Document: NR-SRD-063	NRCSD ICD Change Notice	NANORACKS
Classification: Public Domain	Date: August 11, 2014	Revision 0.1

Document Change Notice (DCN)

NRCSD Guide Rail Width

Figure 5 NRCSD Guide Rail Width (+Z view, +Y top).

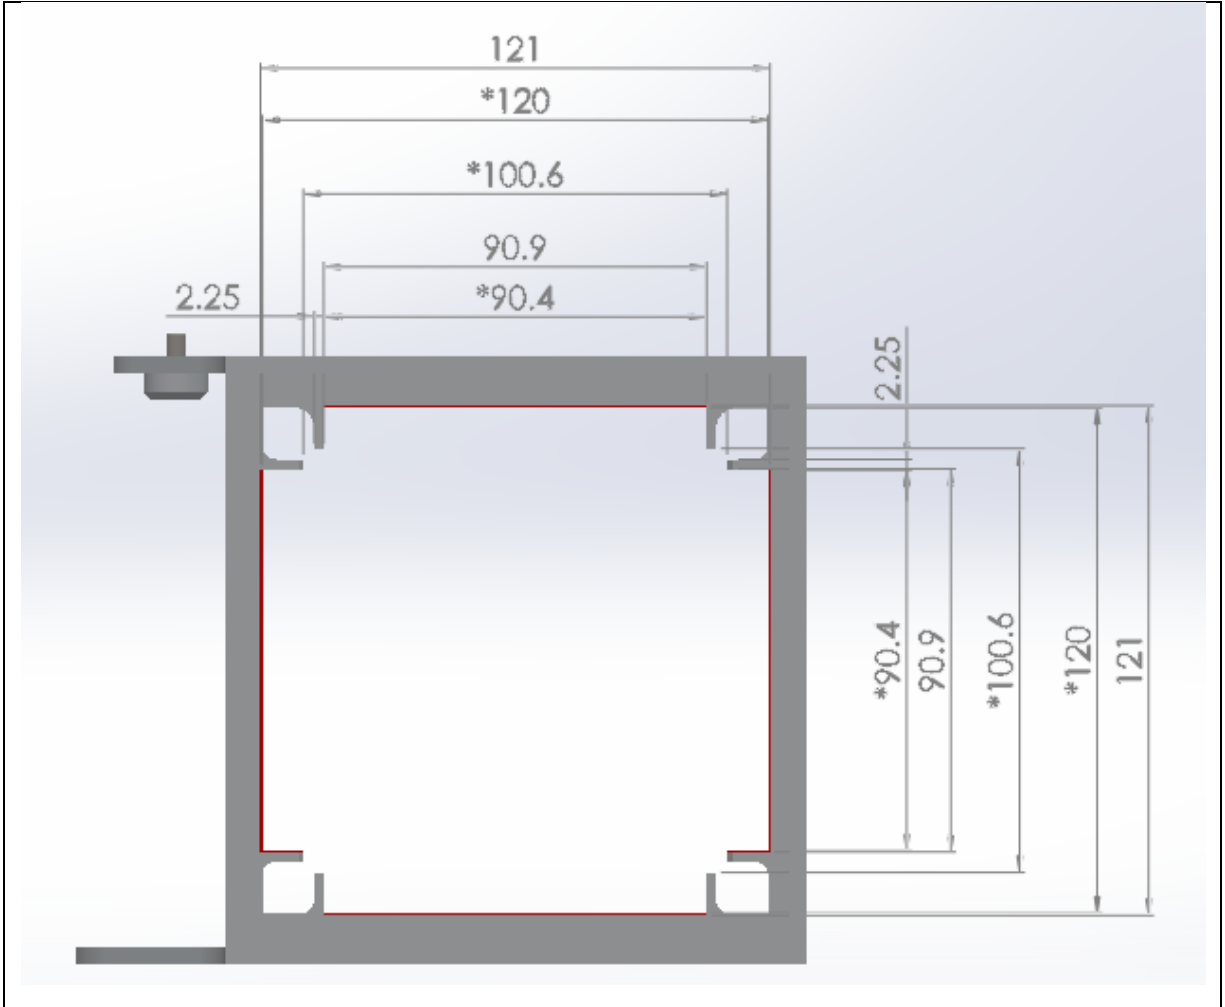
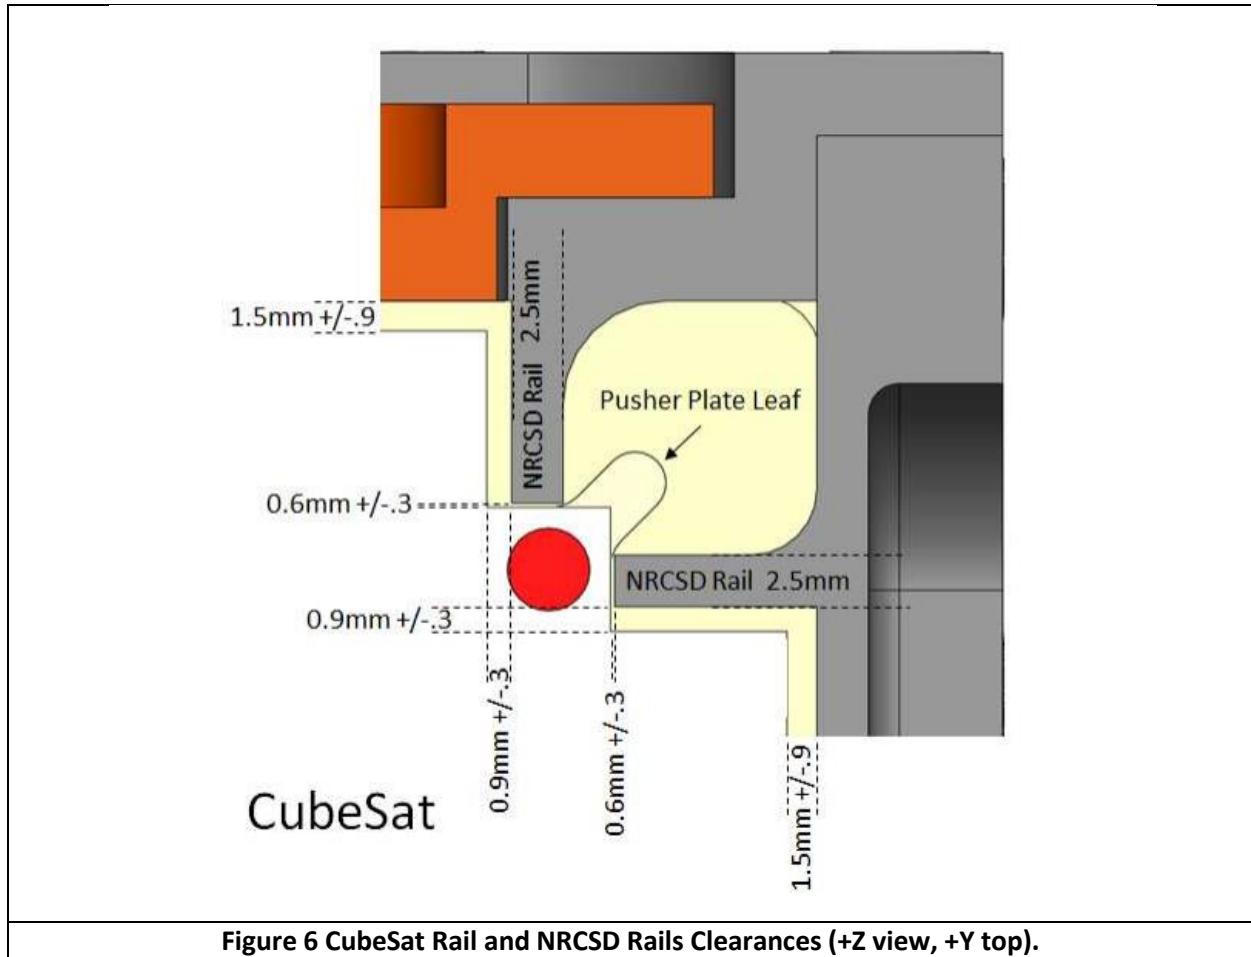
The NanoRacks CubeSat Deployer (NRCSD) interior structure has four sets of guide rails which interface to corresponding CubeSat rails. Section 4.5, Figure 5 of the NRCSD ICD Rev 36, depicts the NRCSD guide rails having width of 2.5mm.

NRCSDs manufactured after June 2014 (NanoRacks CubeSat Mission 2 and thereafter) have guide rail width of 2.25mm as shown in Figure 5 below. There is a difference between the physical envelope and allowable envelope do to the addition of the Keep Out Zone depicted in red. There is no change to the allowable envelope which is denoted in Figure 5 below as dimensions proceeded by an asterisk (*).

Figure 6 CubeSat Rail and NRCSD Rails Clearances (+Z view, +Y top).

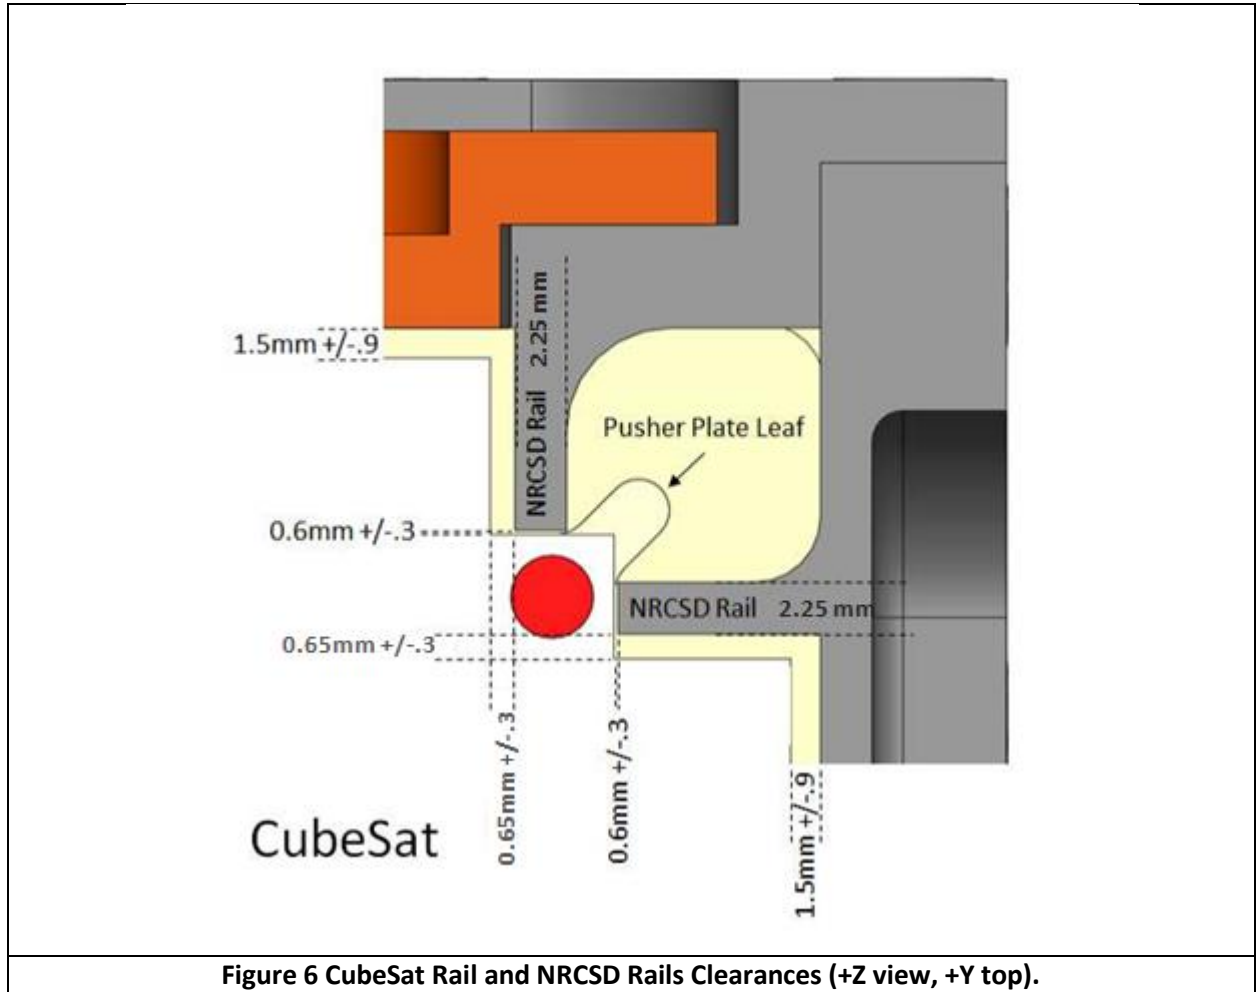
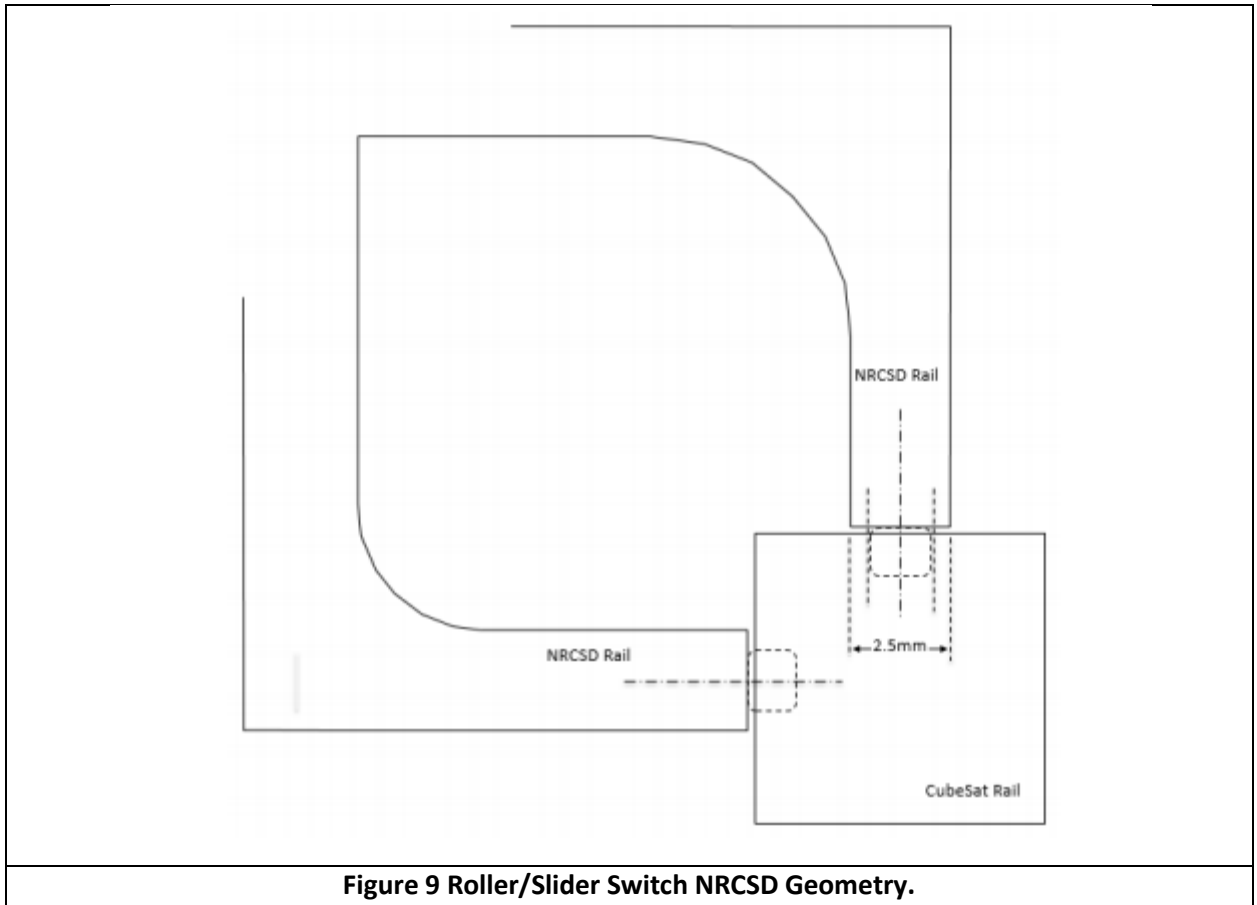
Section 4.5, Figure 6 of the NRCSD ICD Rev 36, depicts the NRCSD guide rails having width of 2.5mm.

NRCSDs manufactured after June 2014 (NanoRacks CubeSat Mission 2 and thereafter) have guide rail width of 2.25mm as shown in Figure 6 below.

Figure 9 Roller/Slider Switch NRCSD Geometry.

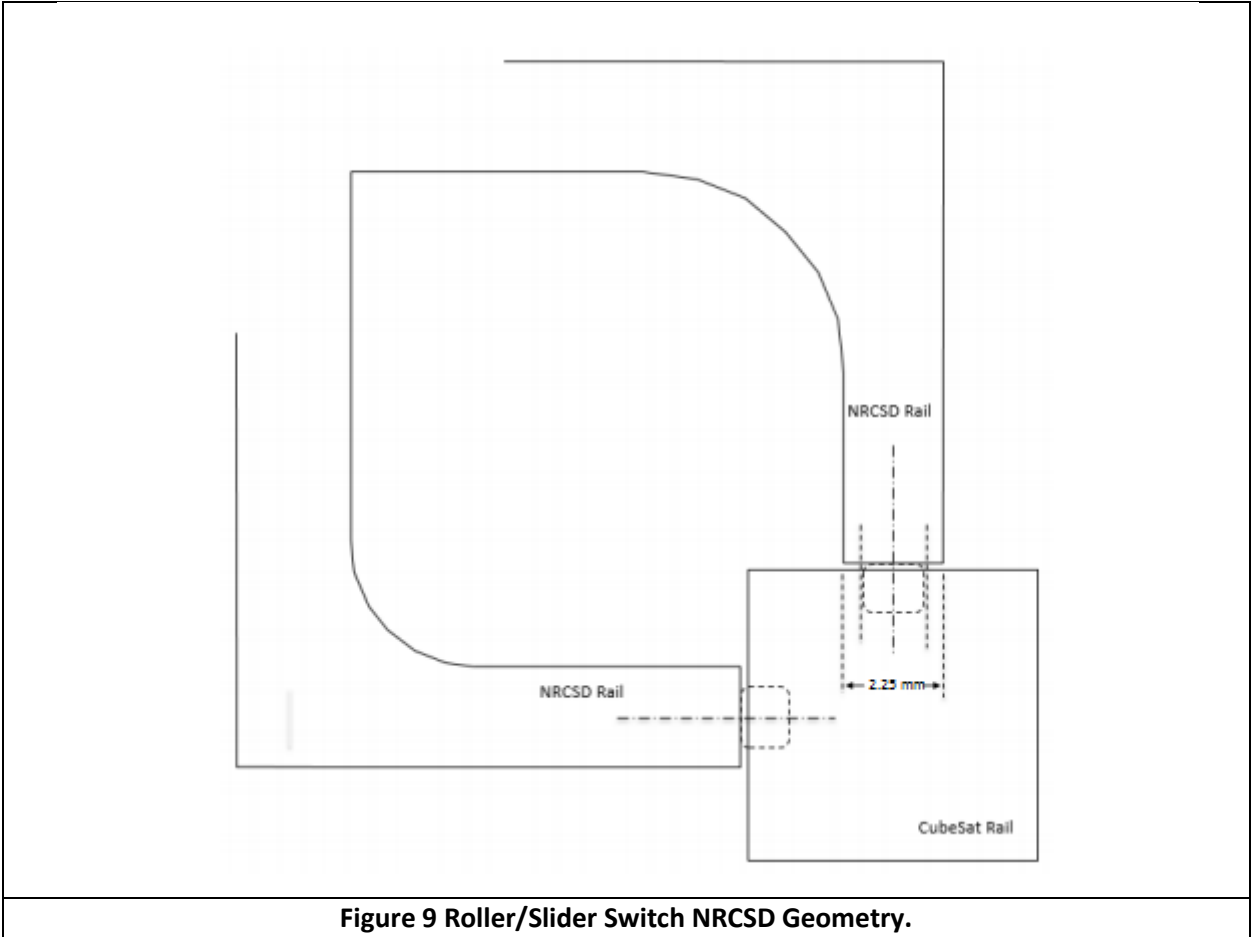
Section 4.7, Figure 9 of the NRCSD ICD Rev 36, depicts the NRCSD guide rails having width of 2.5mm.

NRCSDs manufactured after June 2014 (NanoRacks CubeSat Mission 2 and thereafter) have guide rail width of 2.25mm as shown in Figure 9 below.
